Norfolk Boreas Offshore Wind Farm (EN010087)

Statement of Common Ground

Applicant: Norfolk Boreas Limited
Document Reference: ExA.SoCG-8.D9.V2
Deadline 9

Project:	Highways England Spatial Planning Arrangement 2016-2020	Job No:	60506522 / DN053.002
Subject:	Norfolk Boreas Offshore Wind Farm – EIA Traffic & Transport Method Statement Review		
Prepared by:	Kelly Davis	Date:	16th February 2018
Checked by:	Andrew Cuthbert	Date:	21st February 2018
Verified by:	Liz Judson	Date:	22nd February 2018
Approved by:	Andrew Cuthbert	Date:	22nd February 2018

DRAWN	JJ	CHECKED	RNE	APPROVED	ADR
DATE	08.04.19	SCALE AT A3	1:250	CLIENTS REF.	
DRAWING No.	TP-PB4476-DR028			REVISION	
CLIENT DWG No.					D0.1

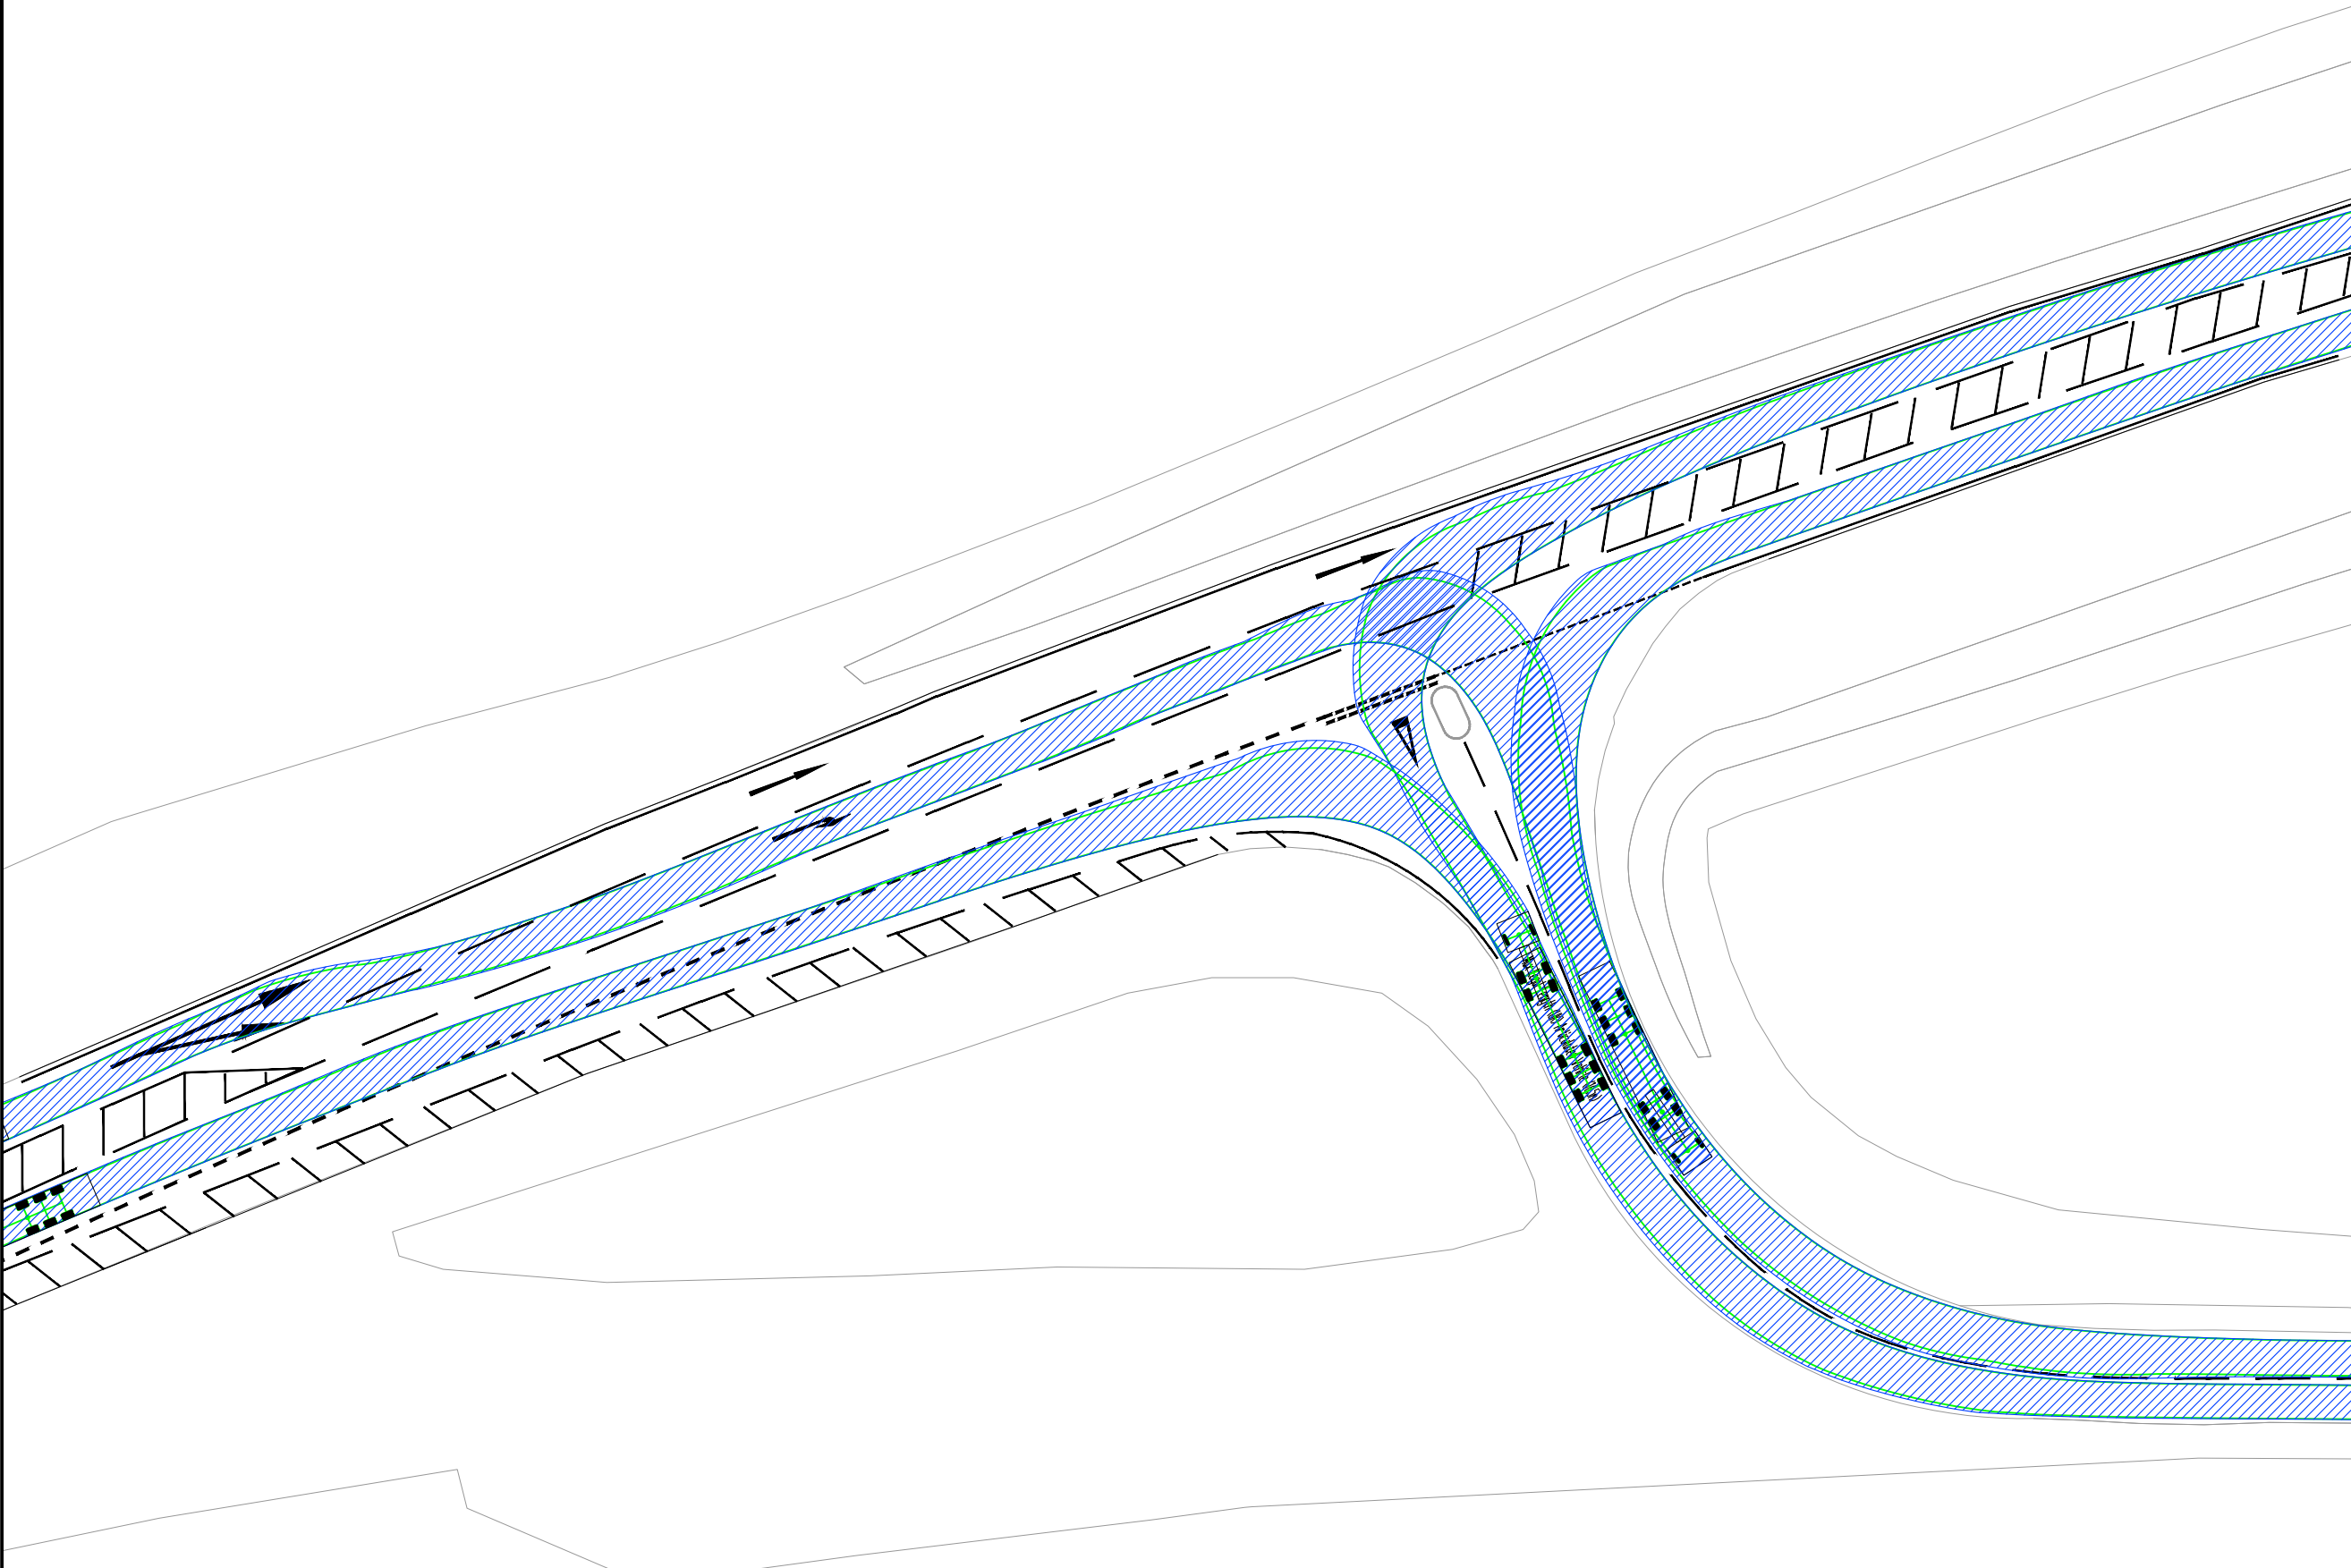
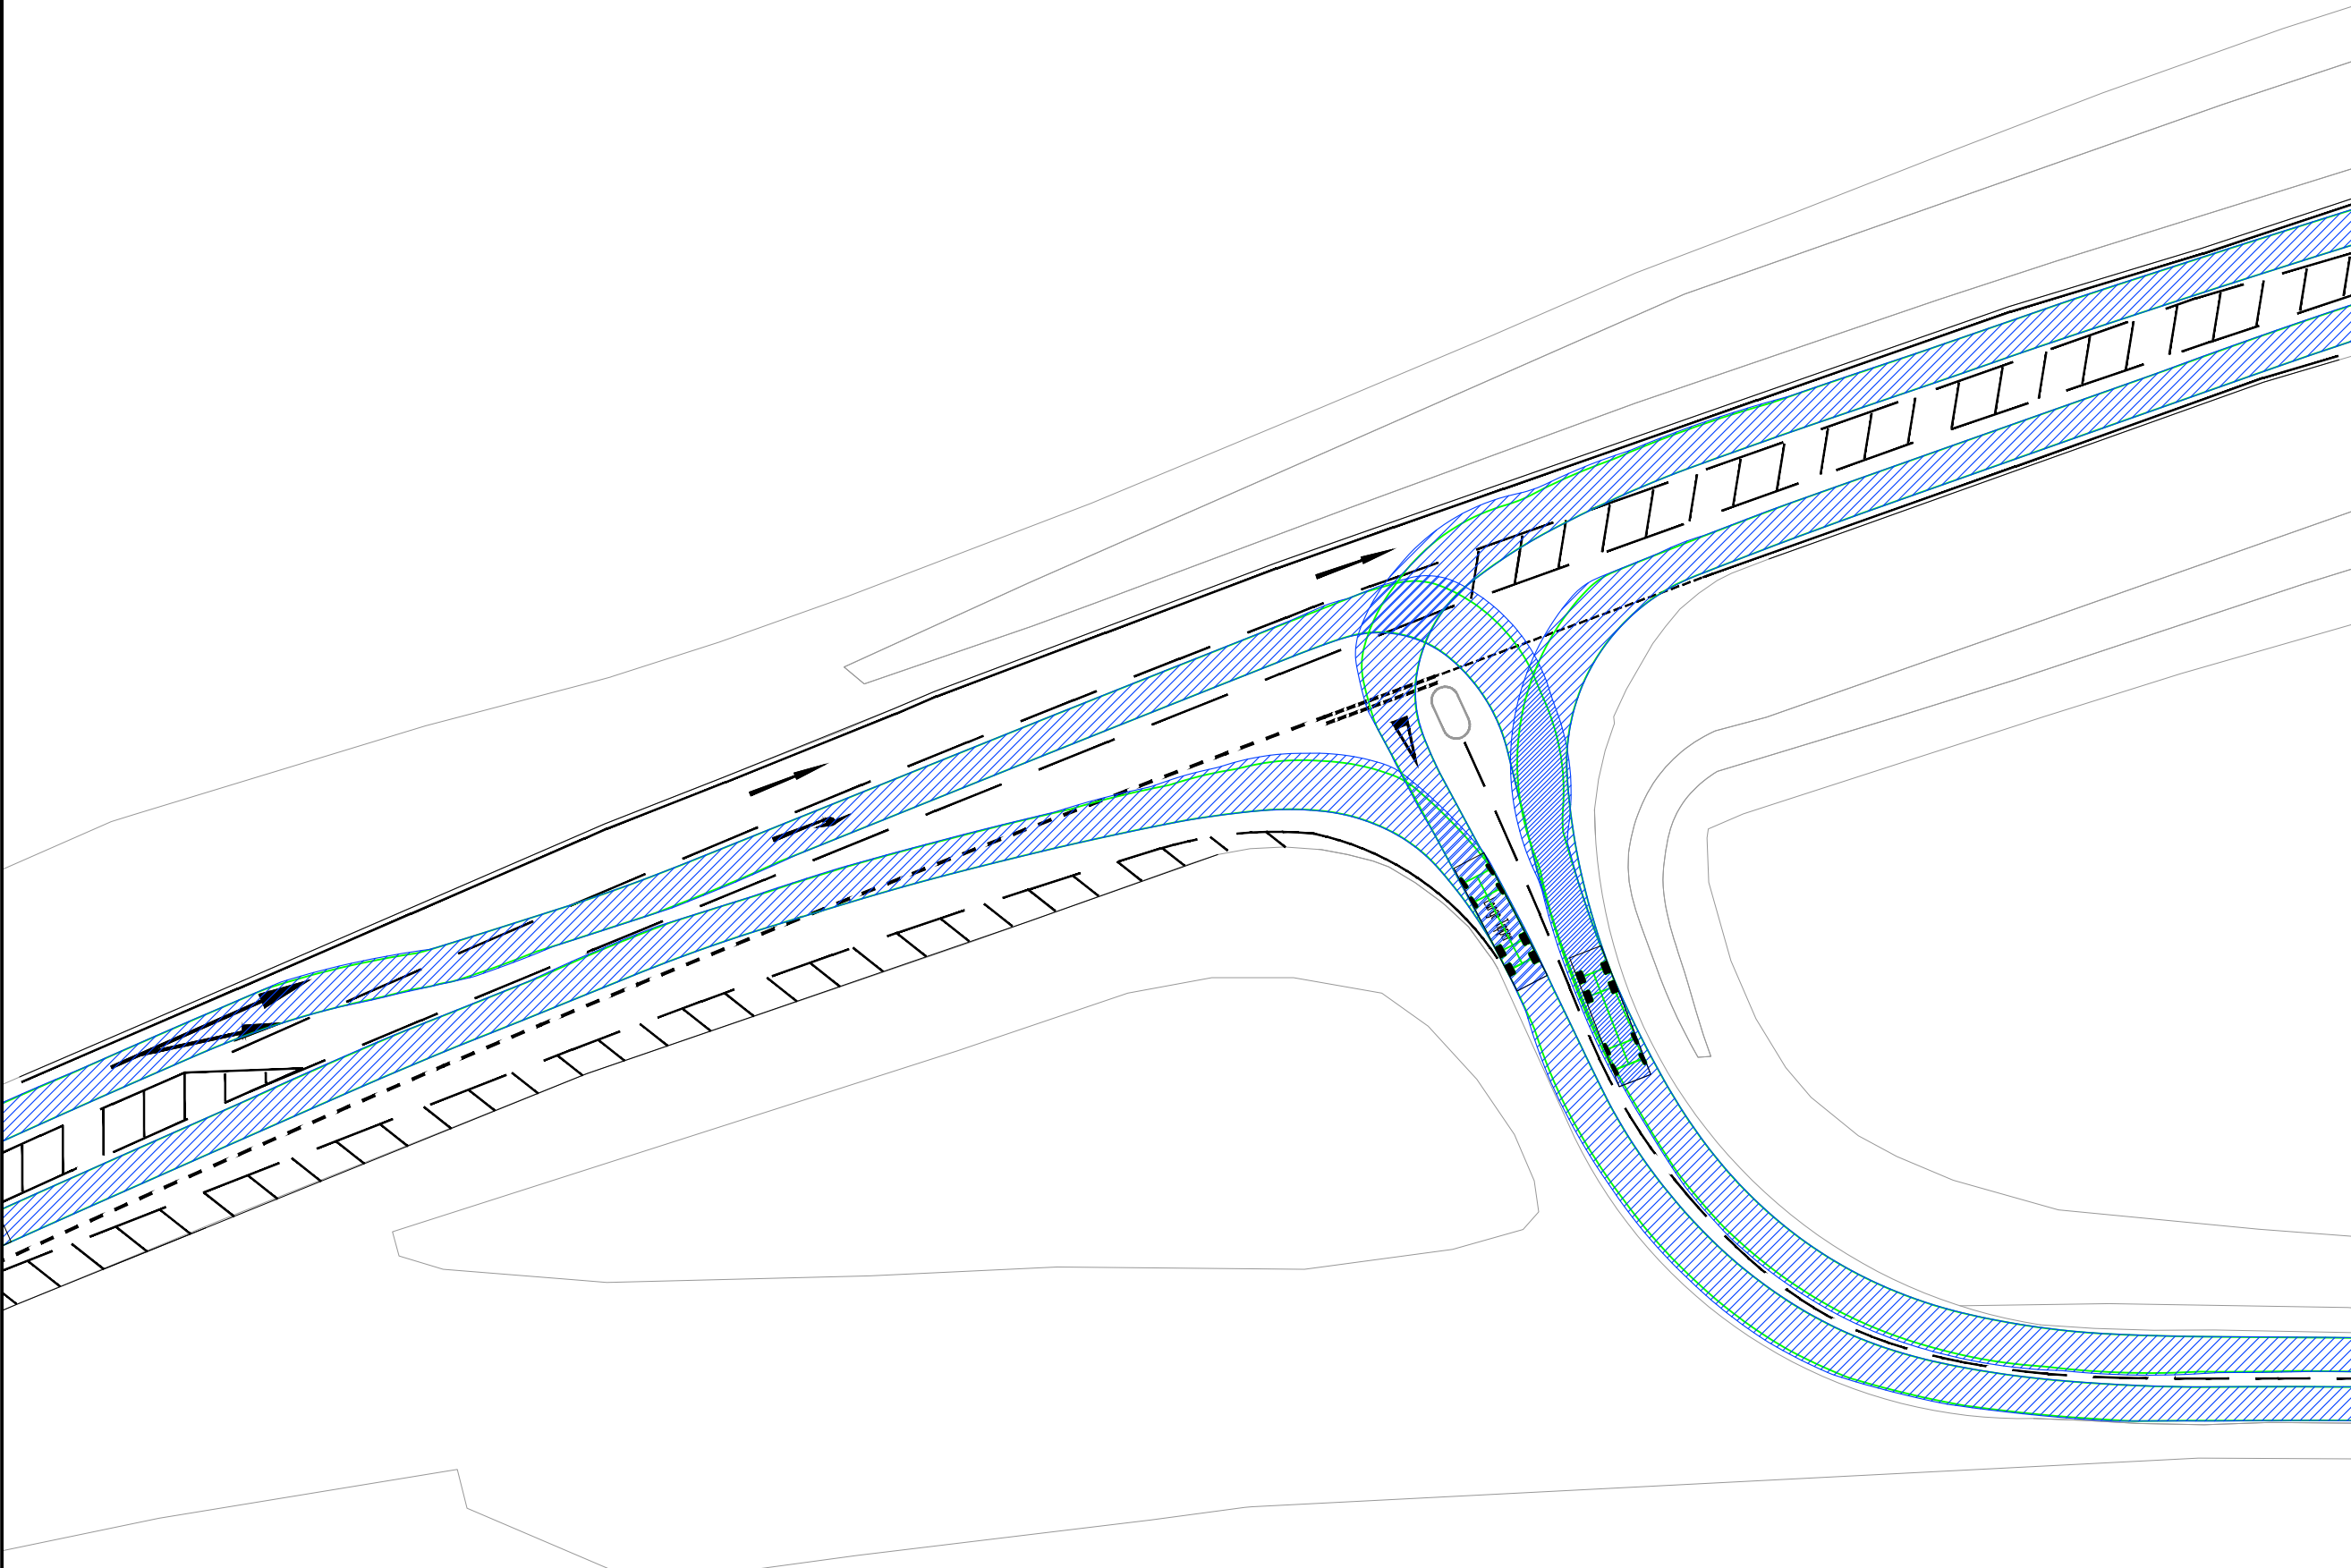
24. This is an existing junction of a relatively high standard. Whilst it does not appear to conform exactly to current DMRB standards, it broadly resembles the layout prescribed for a ghost island junction where the design speed of the main road is 100 km/hr, with corner radii of 20m, consistent with the highest standard required by TD42 at Para 7.17(e). There is a merge taper on to the A47 westbound which would not be provided were this junction being built today (TD42 para 7.59 refers). The swept path plots illustrated on Drawings PB4476 028 and 029 show that the junction can accommodate heavy vehicles turning on and off the A47 without clipping kerb lines, and without encroaching on the wrong side of the A47 or the minor road. No modifications are proposed at this junction to mitigate the impact of the proposed development and AECOM agree that none are required, other than the clearance of overgrown foliage from visibility splays.
